**Indian Creek Intermediate School  
Boiler Replacement  
Trafalgar, Indiana**

**ADDENDUM NO. 2**

**HEAPY PROJECT NO. 2023-06085**

**March 20, 2024**

H101

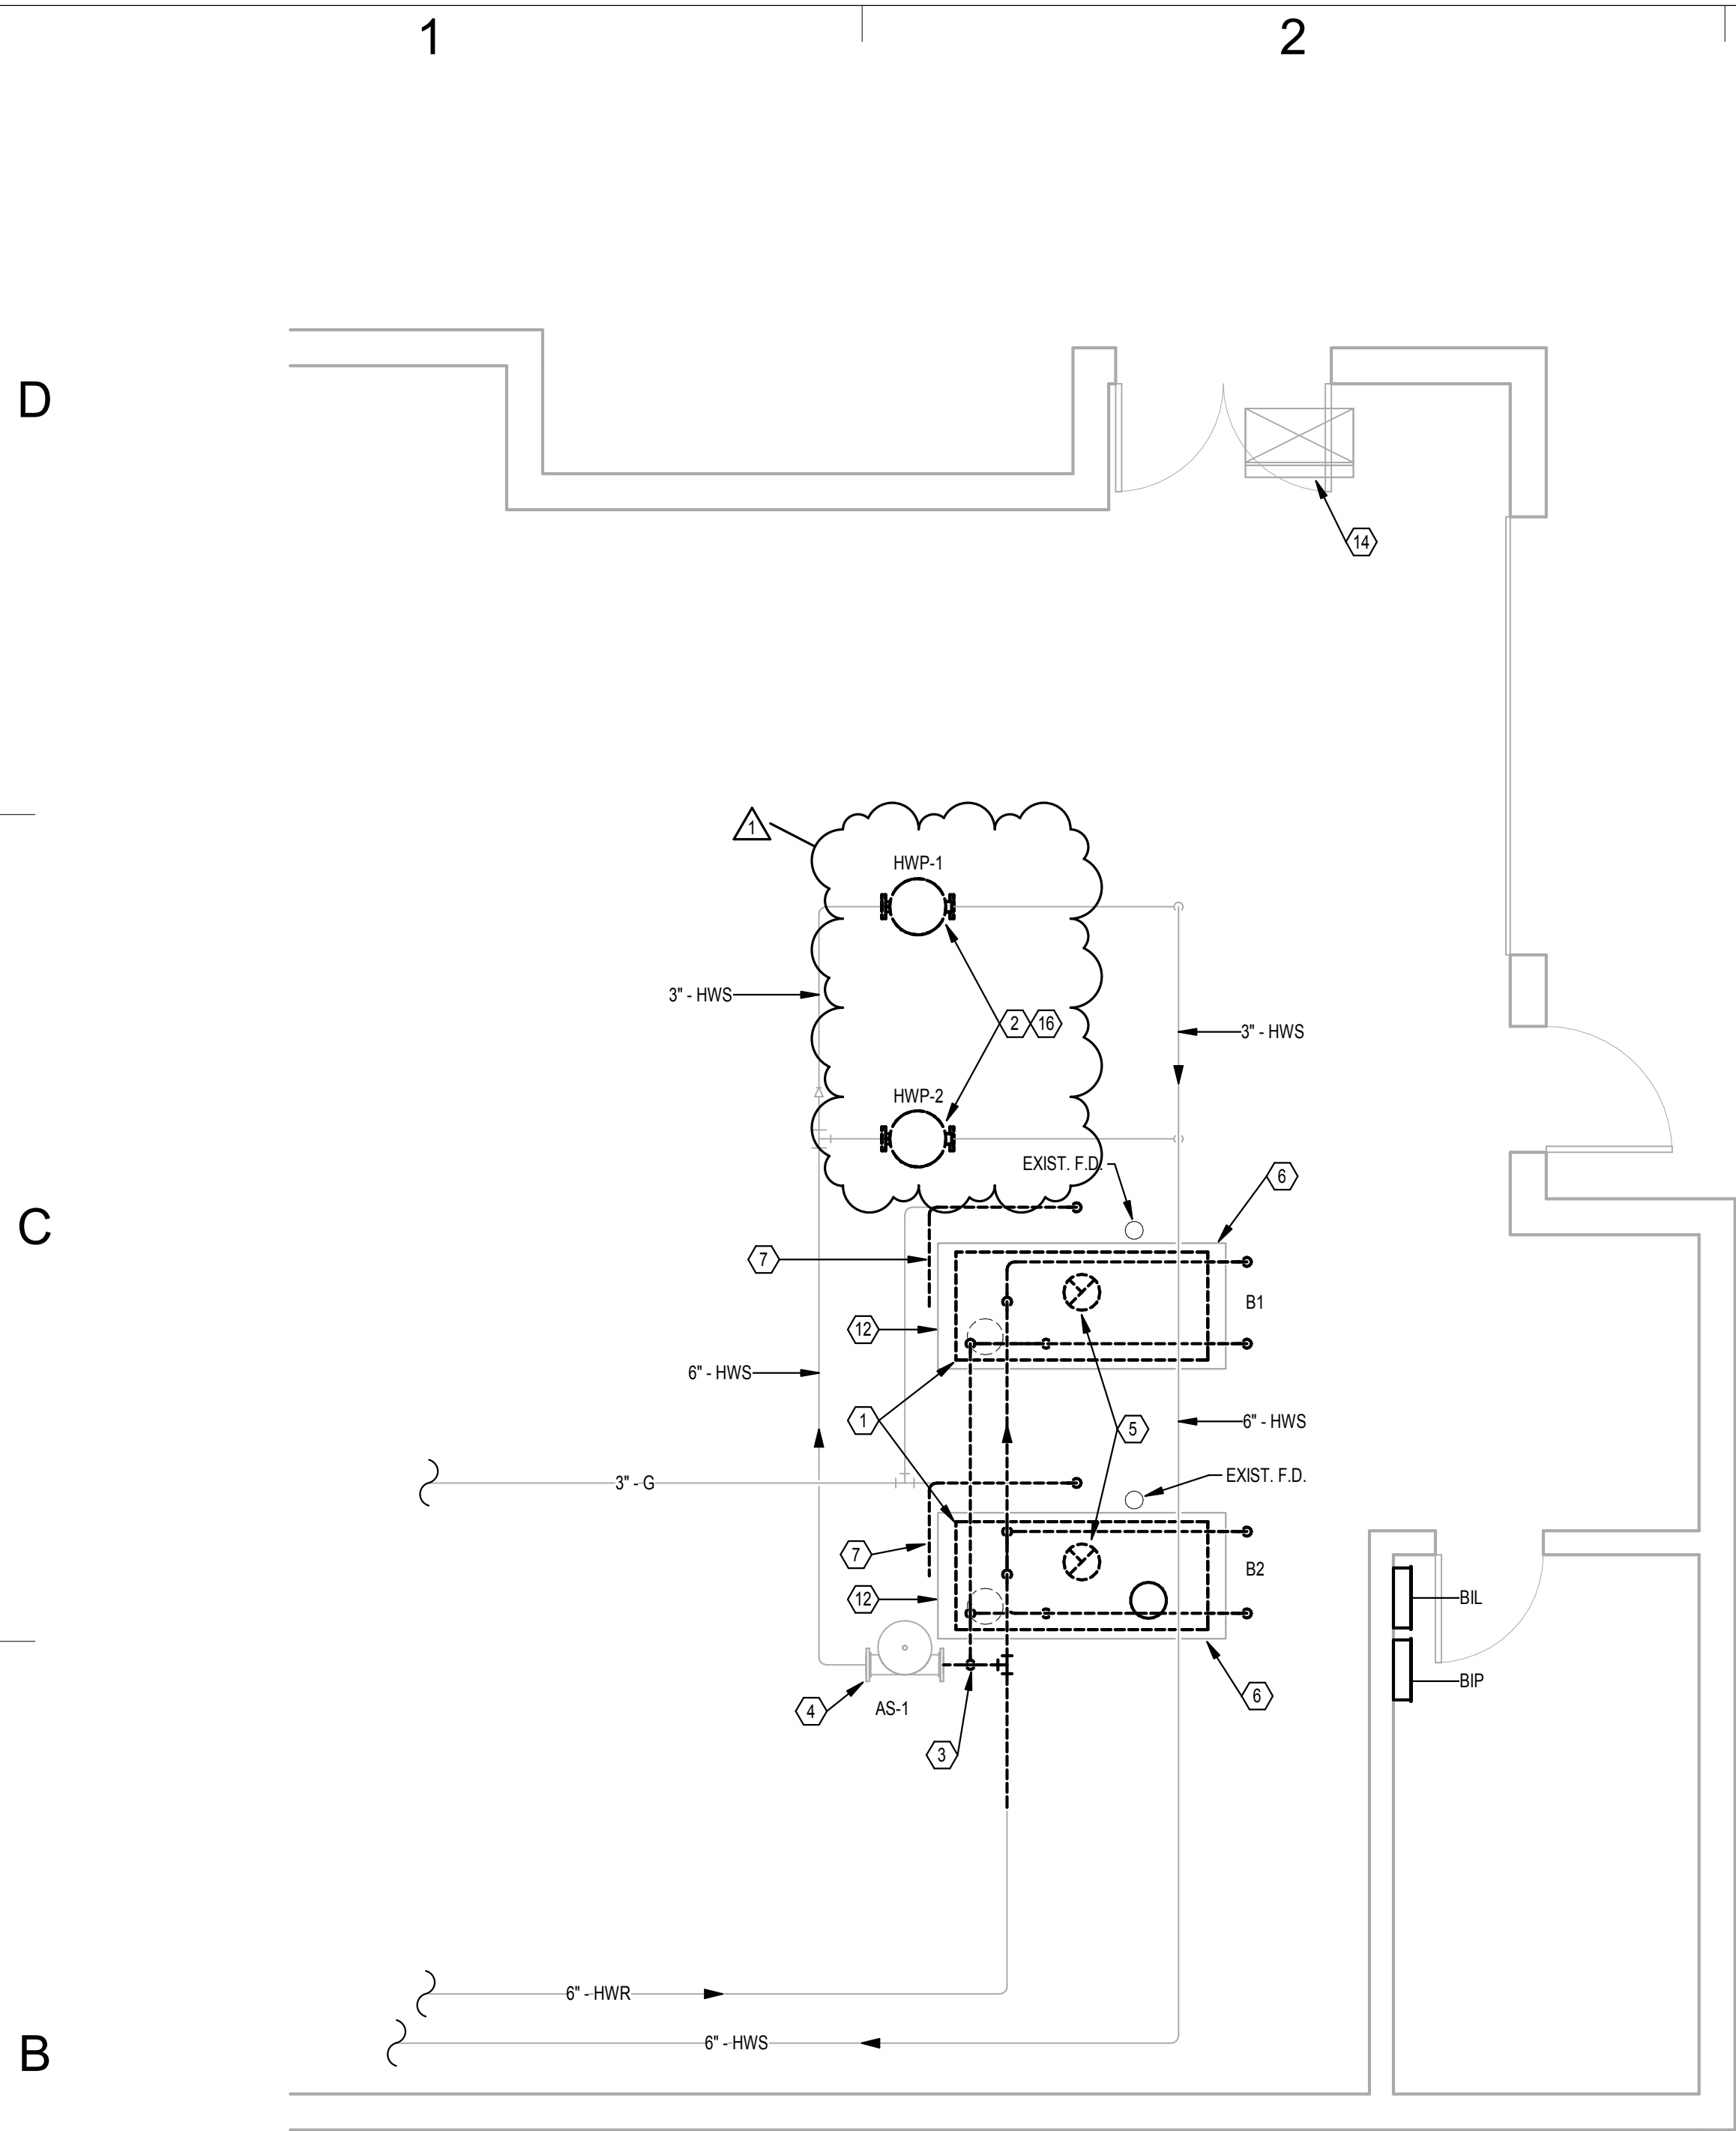
ITEM NO. 1     H101 – DEMO AND NEW WORK PLANS

A.     Replace existing domestic hot water pumps with new hot water pumps.

- 15 NEW HOT WATER PUMPS.
- 16 DISCONNECT EXISTING CIRCUIT SERVING REMOVED PUMPS. CIRCUIT SHALL REMAIN FOR RECONNECTION.
- 17 RECONNECT EXISTING CIRCUIT THAT SERVED REMOVED PUMPS TO NEW DOMESTIC HOT WATER PUMPS. EXTEND AS REQUIRED.

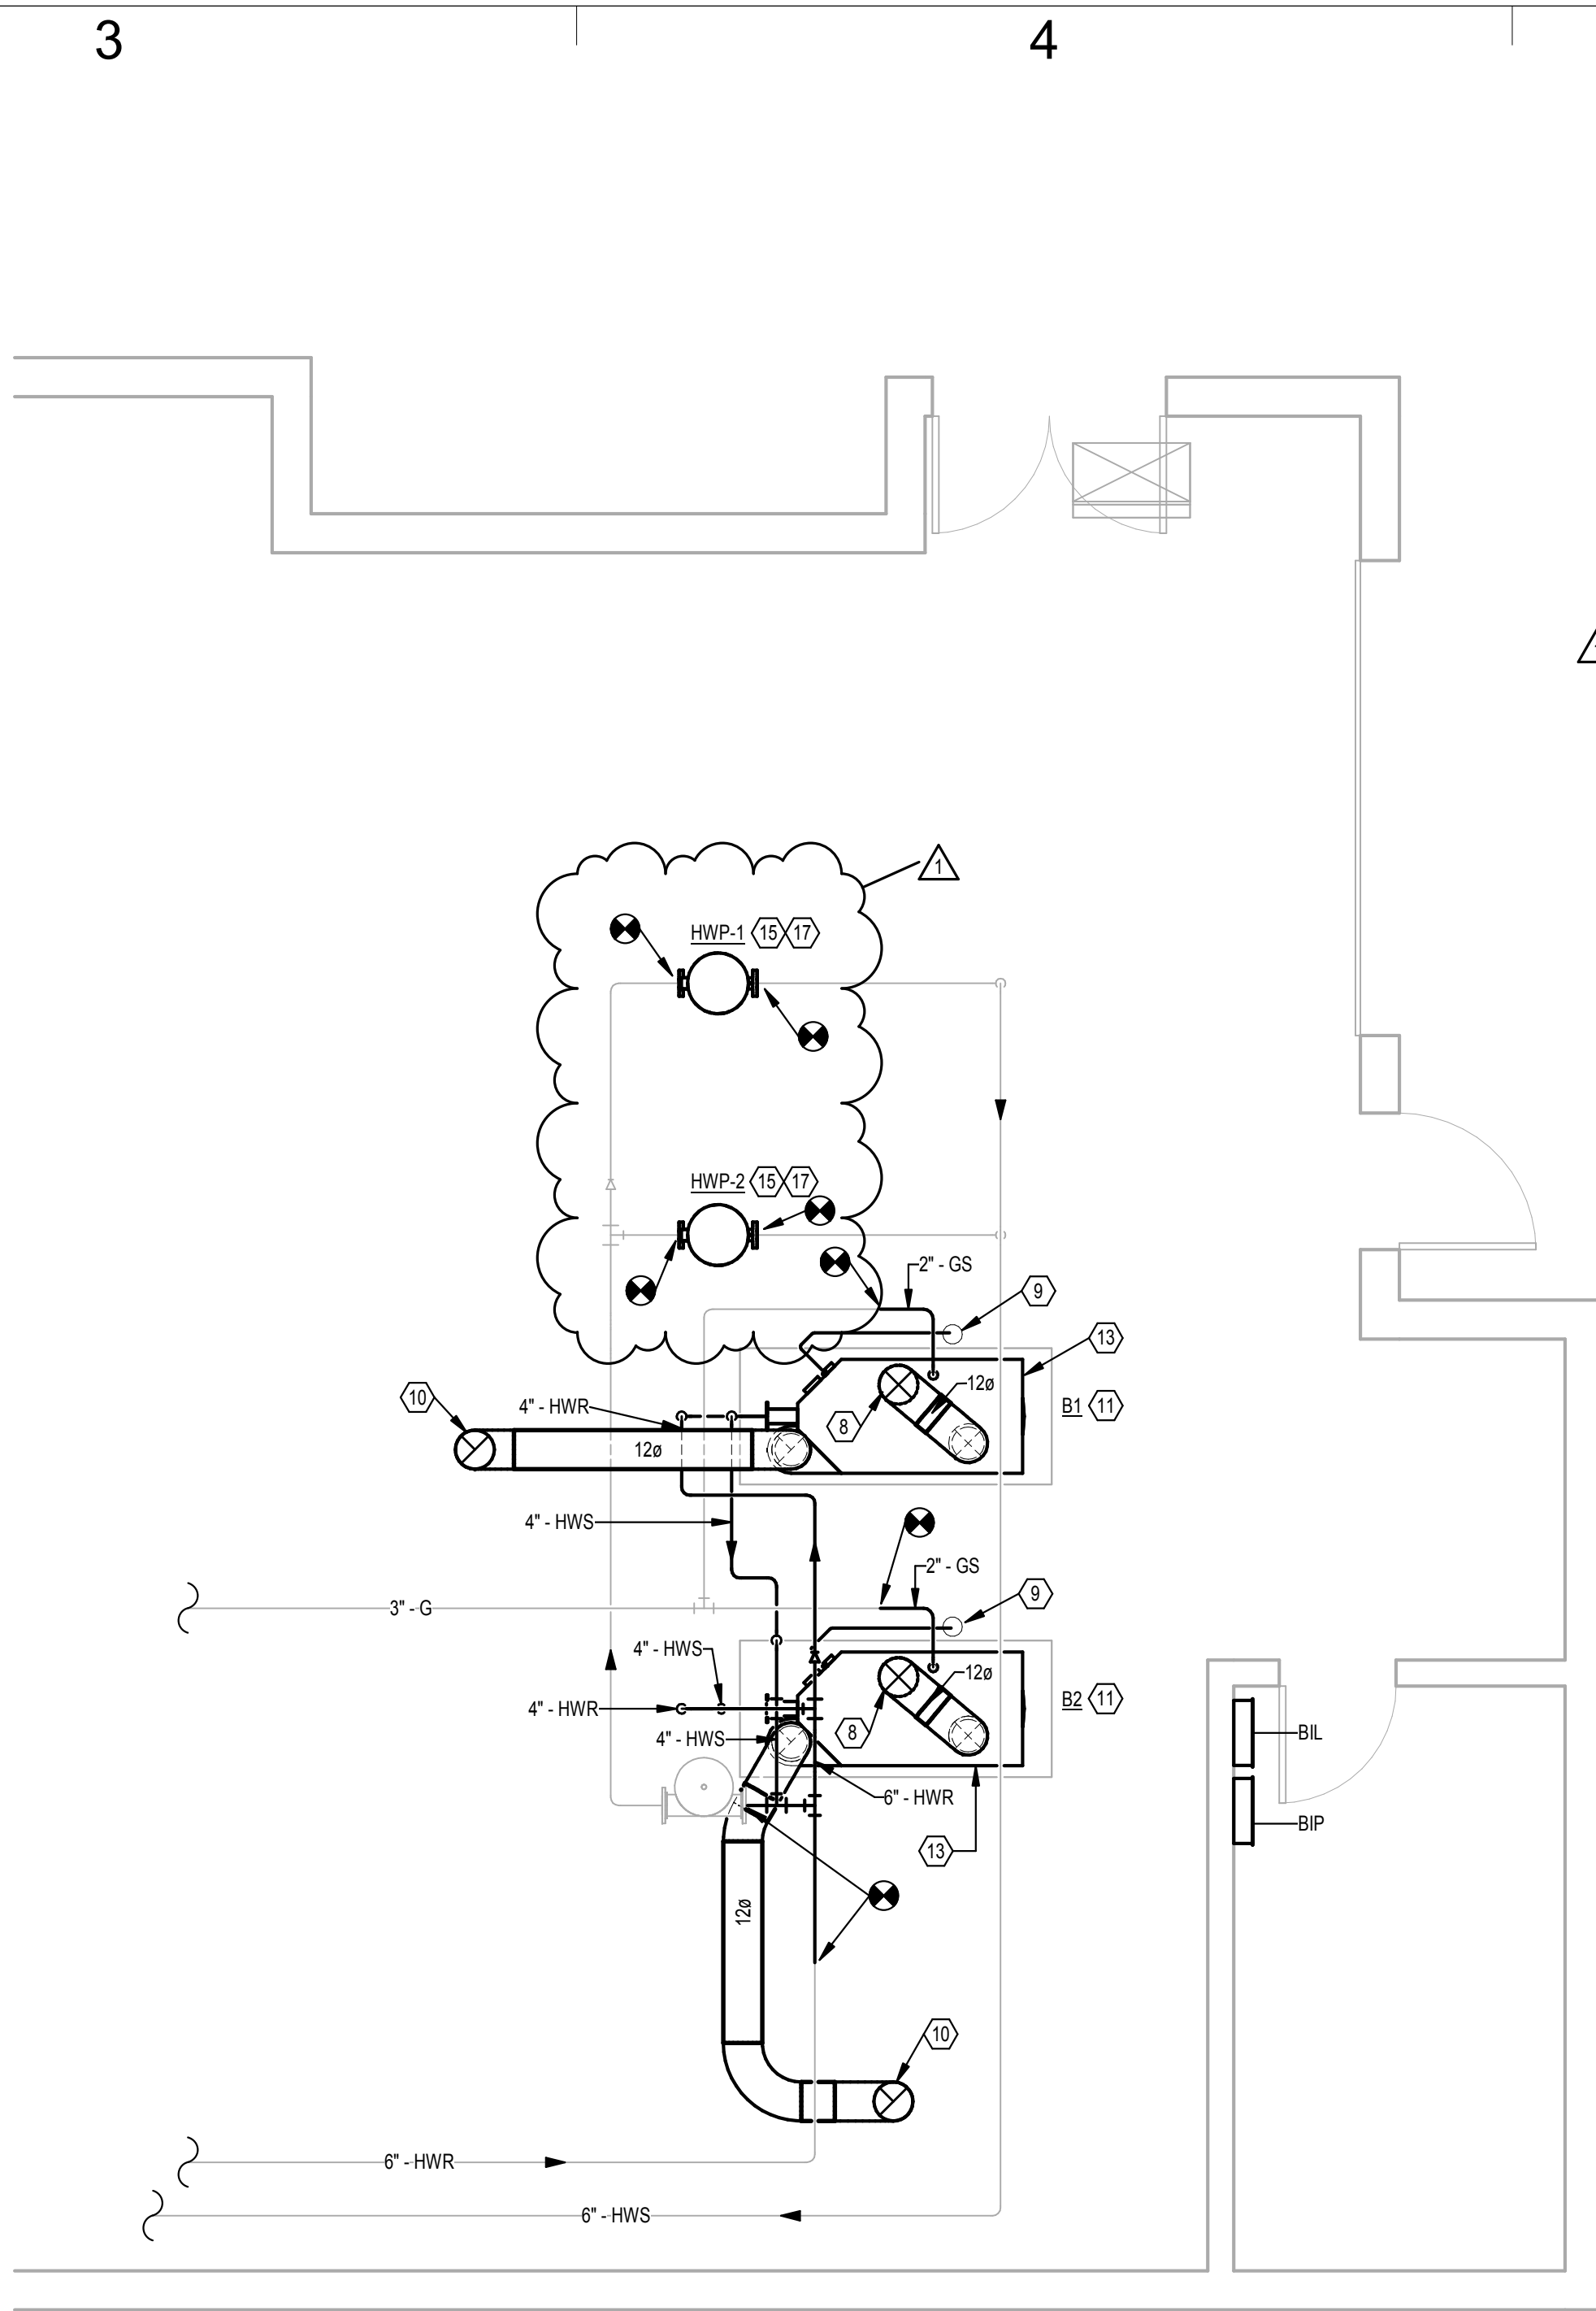
ITEM NO. 2     H500 – SCHEDULES, DETAILS, & SPECS

A.     Update schedule as indicated.
